Council Assessment Panel Minutes

19 January 2026

5.1 DEVELOPMENT NUMBER ID 25002154 - PETER PILIOURAS - 33A -33B ANN STREET STEPNEY SA 5069

DEVELOPMENT NO.:	25002154
APPLICANT:	Peter Piliouras
ADDRESS:	33A -33B ANN ST STEPNEY SA 5069
NATURE OF DEVELOPMENT:	Two-storey alterations and additions to existing residential flat building containing two dwellings (Local Heritage Place), including internal demolition, restoration works, and associated timber picket front fence and replacement side fencing
ZONING INFORMATION:	<p>Zones:</p> <ul style="list-style-type: none"> Established Neighbourhood <p>Overlays:</p> <ul style="list-style-type: none"> Airport Building Heights (Regulated) Historic Area Hazards (Flooding - General) Local Heritage Place Prescribed Wells Area Regulated and Significant Tree Stormwater Management Traffic Generating Development Urban Tree Canopy <p>Technical Numeric Variations (TNVs):</p> <ul style="list-style-type: none"> Minimum Frontage (Minimum frontage for a detached dwelling is 8m; semi-detached dwelling is 8m) Minimum Site Area (Minimum site area for a detached dwelling is 200 sqm; semi-detached dwelling is 200 sqm; row dwelling is 200 sqm) Maximum Building

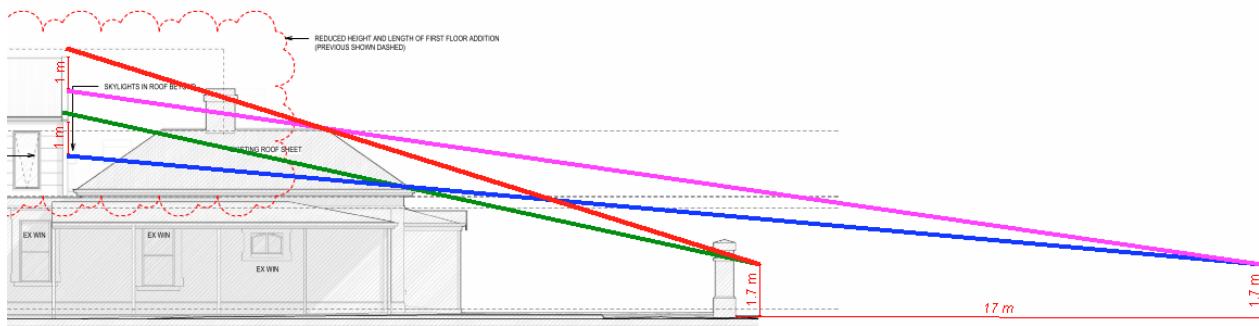
The upper floor is set back some 21.5m from the street boundary, behind the original part of the building. Nonetheless, as mentioned by one of the representors, the addition’s walling would not be entirely obscured by the roof of the original building. This is in part due to the walls of the addition extending beyond the lines of the ridges, and because on the southwestern side of the addition is a gable end. The ridge of the gable is 600mm “inboard” of the pitching point of the original roof, mitigating its prominence somewhat.

The image below shows the approximate “view angles” from a pedestrian (with an eye height of 1.7m) from either side of Third Avenue, with an oblique view over the eave/guttering of the original dwelling, and over the ridge. This illustrates that from the near side of the street, there would be little visibility of the upper floor, only of the gable ended portion from an oblique view (such as along the driveway). From the opposite side however, approximately 1m of wall would be visible from an oblique view, and 1m of gable from directly in front.

The overall outcome is one where the upper floor would be visible from the street, mainly along the driveway, but it would not be visually prominent. This is because the context, with the outwardly two-storey Local Heritage Place to the southwest.

A representor suggests that the addition: *“will appear as a new and incongruous element relative to the existing dwelling and also within the streetscape. In effect the upper level will be distinctly different and one that confuses the presentation of and diminishes the value of the contribution made by the existing dwelling.”*
